PROJECT NAME
CHILDREN'S HOSPITAL
OF ORANGE COUNTY
455 S. Main St.
Orange, CA 92668-3874

TOWER II
CHOC
HOSPITAL

DRAWING TITLE
LEVEL 1 ENLARGED PLAN
AREA - K

DRAWING NUMBER
A3.1K

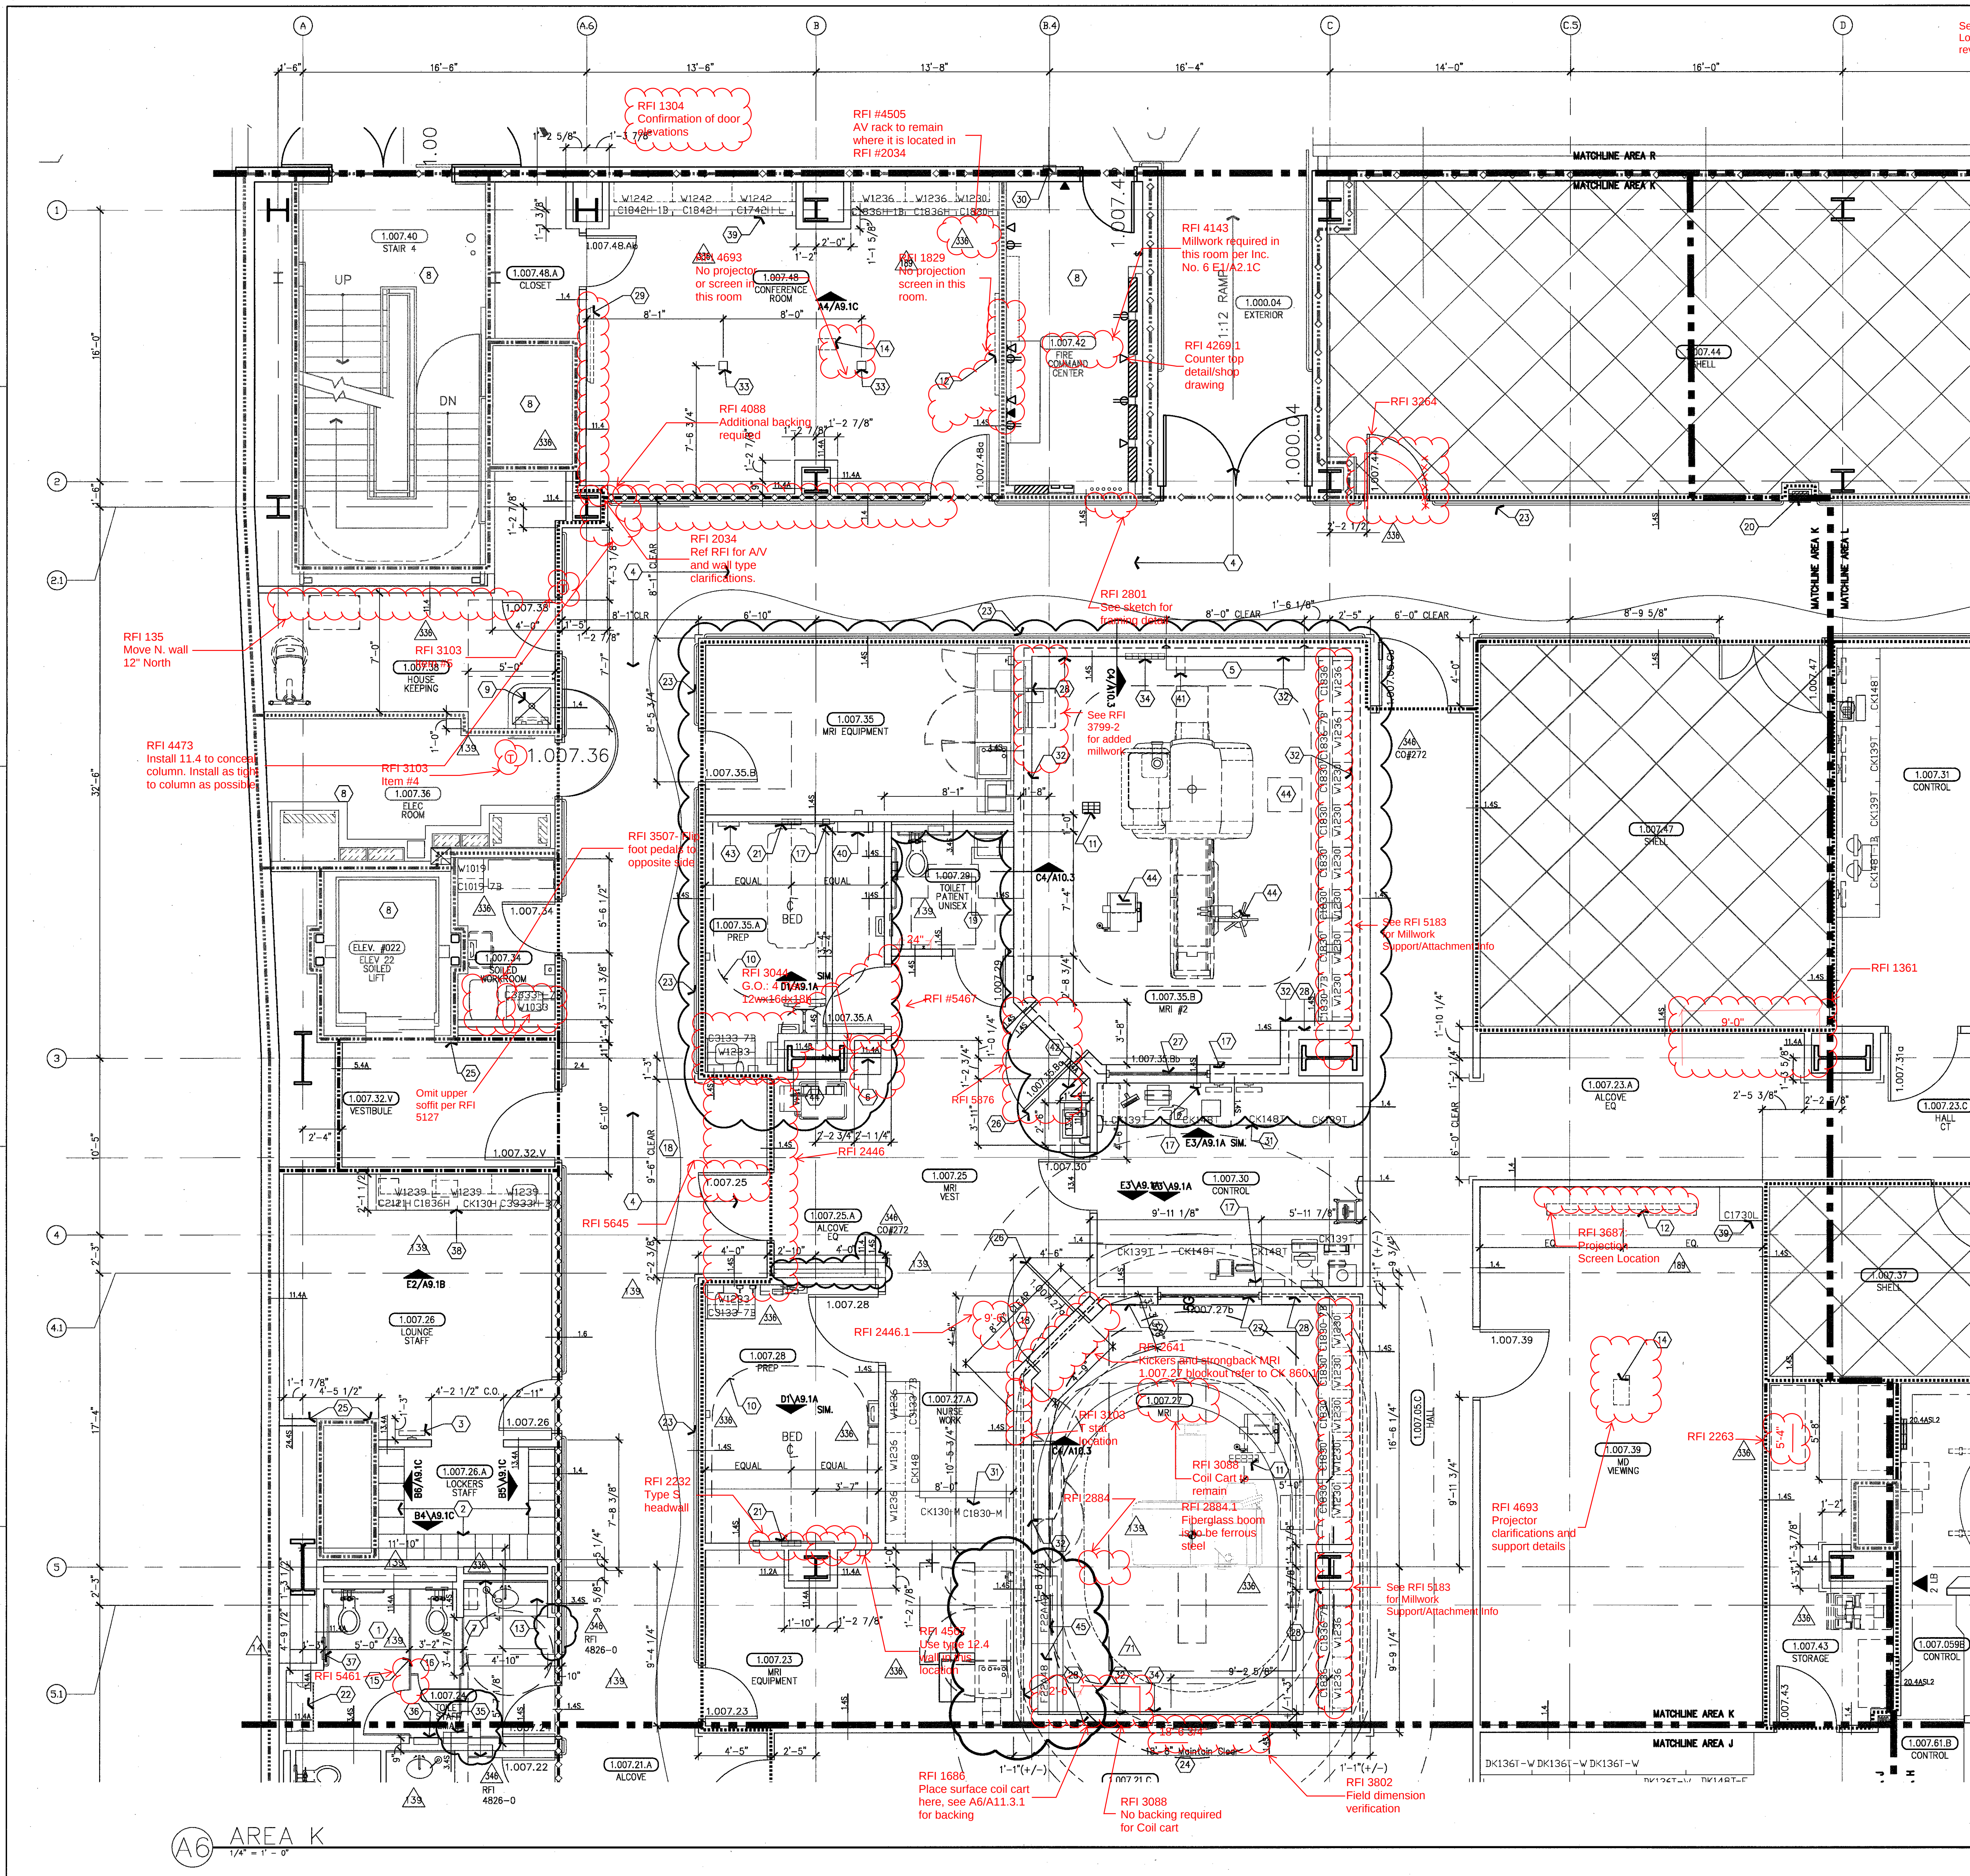
- See RFI 4844; Locker QTY revised
- Accessable toilet stall. See typical plan detail B1/A11.7.1. 3 high (31 total). See referenced elevation.
12. Hanging, wall-mounted, white, plastic laminate finish, Type E, 3 high (31 total). See referenced elevation.
